NOTE ON CORRECTION

Sheet 3 of 3

Corrected Plat of Survey of Valley View Mall

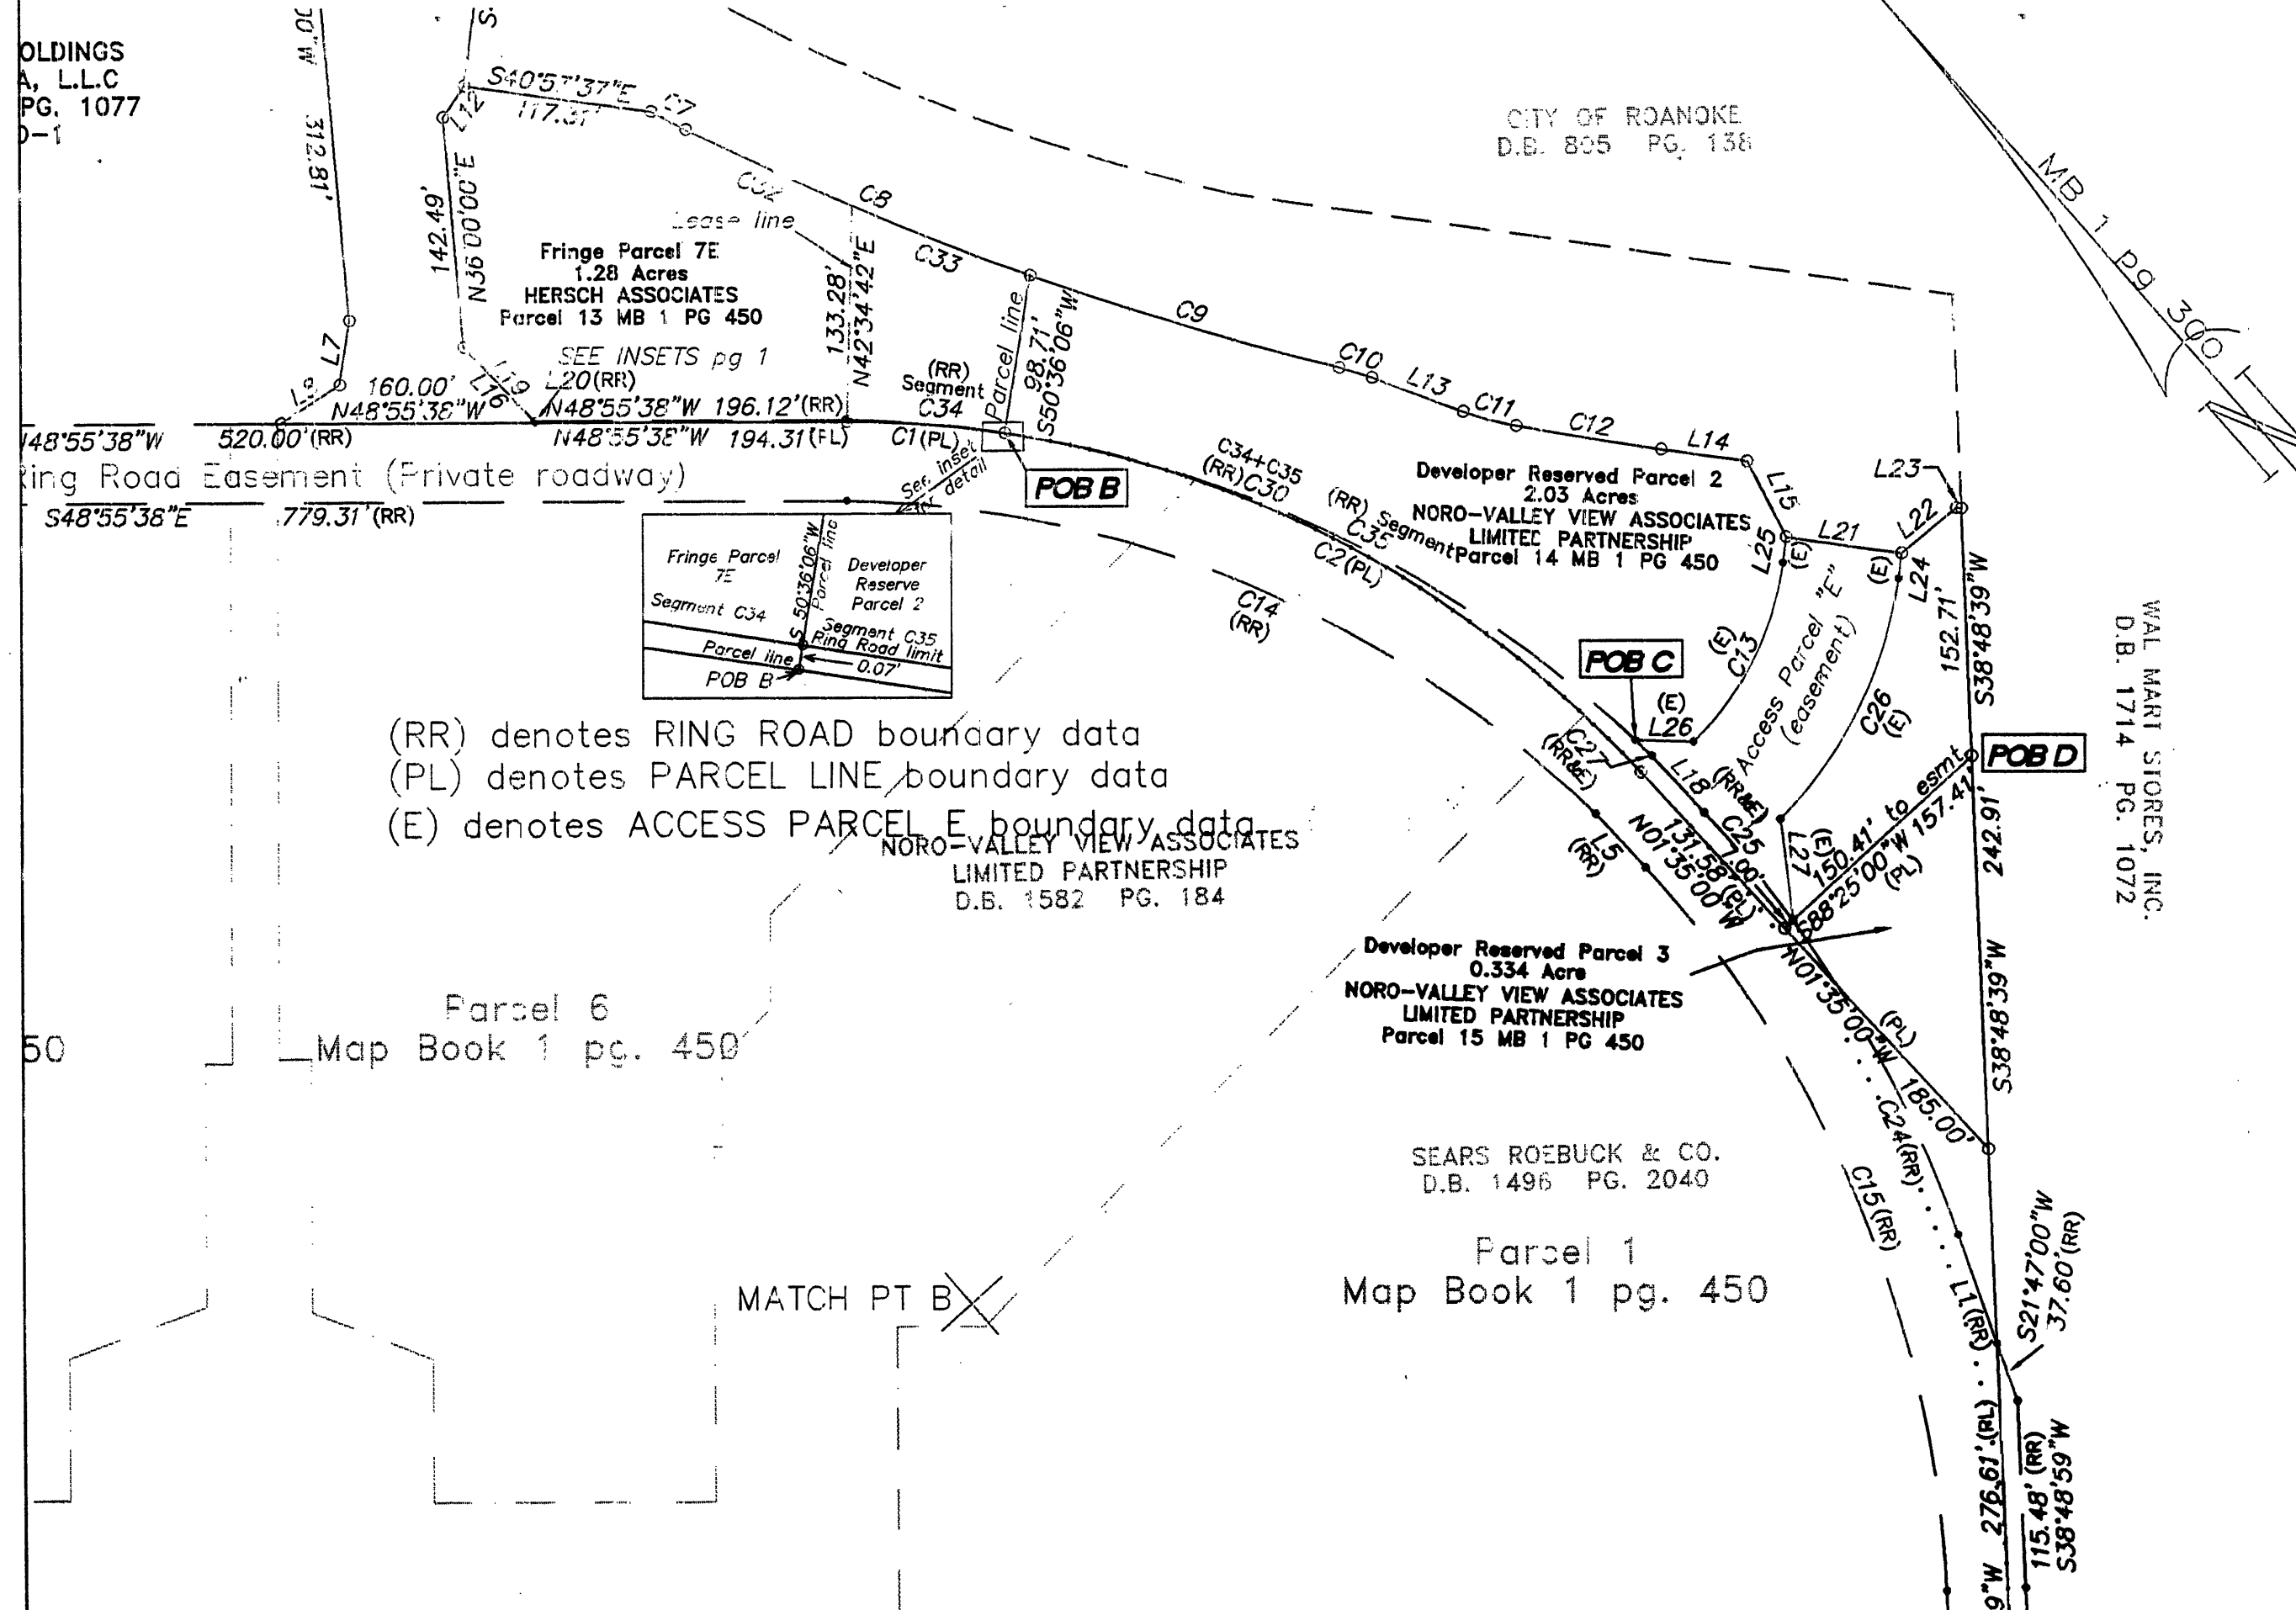
This three page plat of survey was originally recorded in MB 1 pp 1731-1733. There was an erroneous reference made in the descriptive text of each sheet title block and on sheet 2 of 3 on the face of the survey to MB 1 pg. 1934, the correct reference is MB 1 pg. 1394. The sole purpose of this plat is to correct that reference.
